SEWAGE DISPOSAL SYSTEM
HOWARD COUNTY HEALTH DEPARTMENT
BUREAU OF ENVIRONMENTAL HEALTH
410-313-2640

A REPAIR

SUBDIVISION _____ LOT NUMBER _____ ADDRESS 280 E Watersville Road

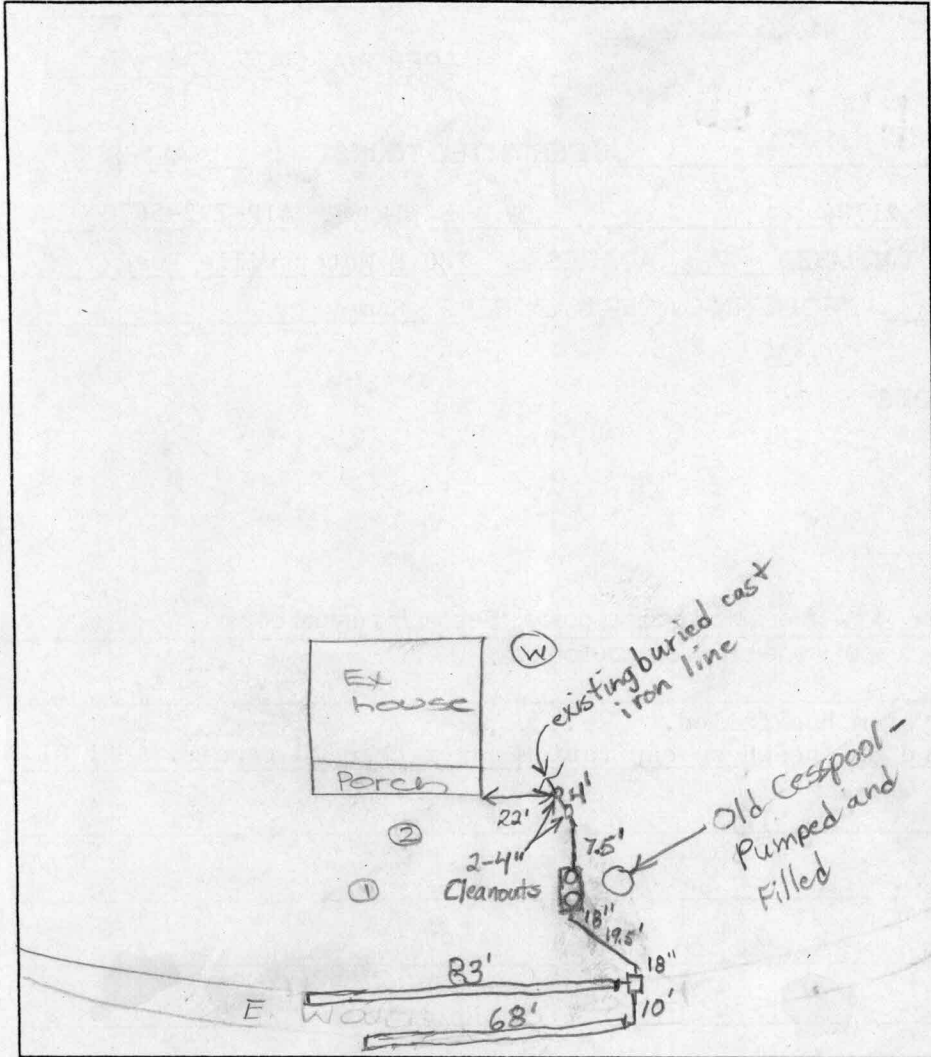
Install 2-90' trenches near to perc hole closer to house
Trenches to be 7' edge to edge
old tank to be pumped and collapsed.

INSPECTION COMMENTS: 8/8/01 System satisfactory. Plastic septic tank and infiltrators used. Old cesspool pumped and filled with dirt. O.K. to cover. (BB)
